1 Q. MHI is aware that a comprehensive reliability report for the entire project has been
2 requested from Nalcor by the Board in a letter July 12, and this document was filed
3 August 17, 2011.

1 Q. Exhibit #30, page 24 shows a simplified single line diagram of the Muskrat Falls converter
2 station. Please provide a complete single line diagram and major equipment data of the
3 Muskrat Falls converter station.

SOLDIERS POND TERMINAL STATION 230 kV SINGLE LINE DIAGRAM	SYS PLANNING: PWT	SHEET 1 OF 1
		SYS OPERATIONS: RB/KG	DATE: JULY 22, 2011
		TERM DESIGN:	DRAWN BY: JF
		PROTECTION:	FILE: soldiers pond 230 kv ac SKF

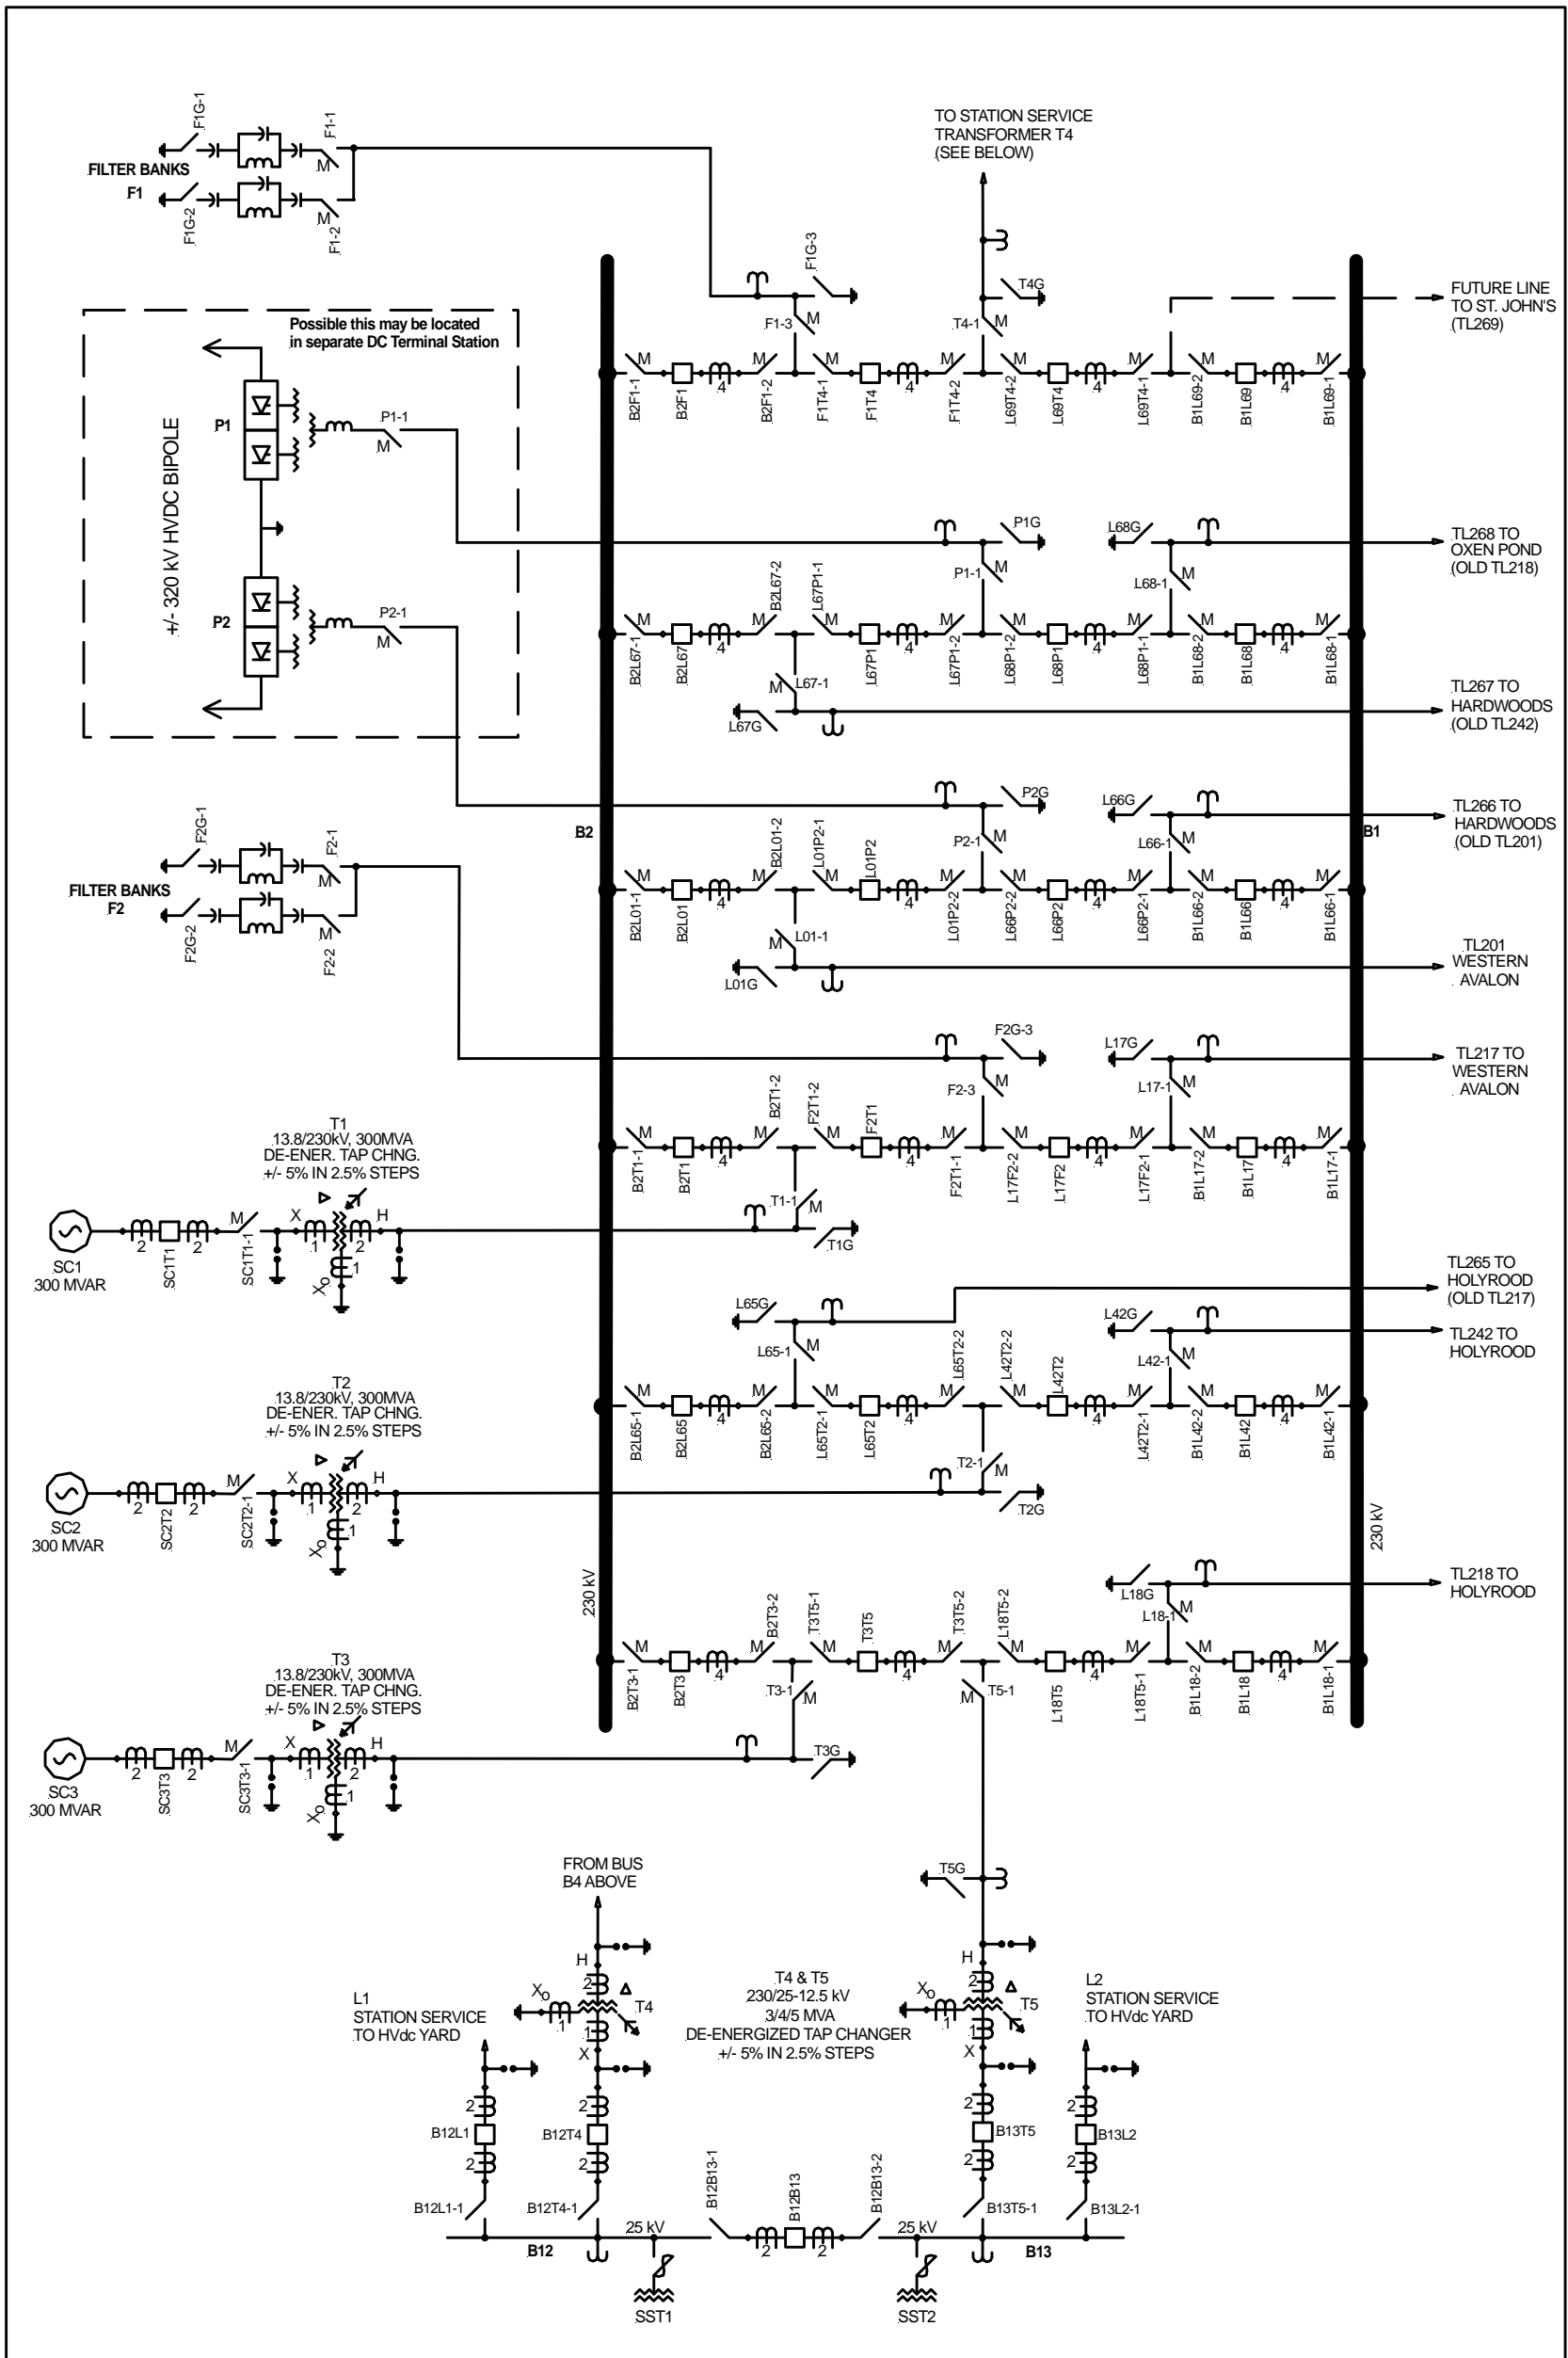
1 Q. Please provide a complete single line diagram and major equipment data for the
2 Soldiers Pond converter station.

5 A. A detailed single line diagram for Soldiers Pond is under consideration and is not yet
6 available. Detailed studies are in progress to define system characteristics that will
7 lead to the identification of major equipment data.

9 A single line diagram with additional detail can be found on the next page.
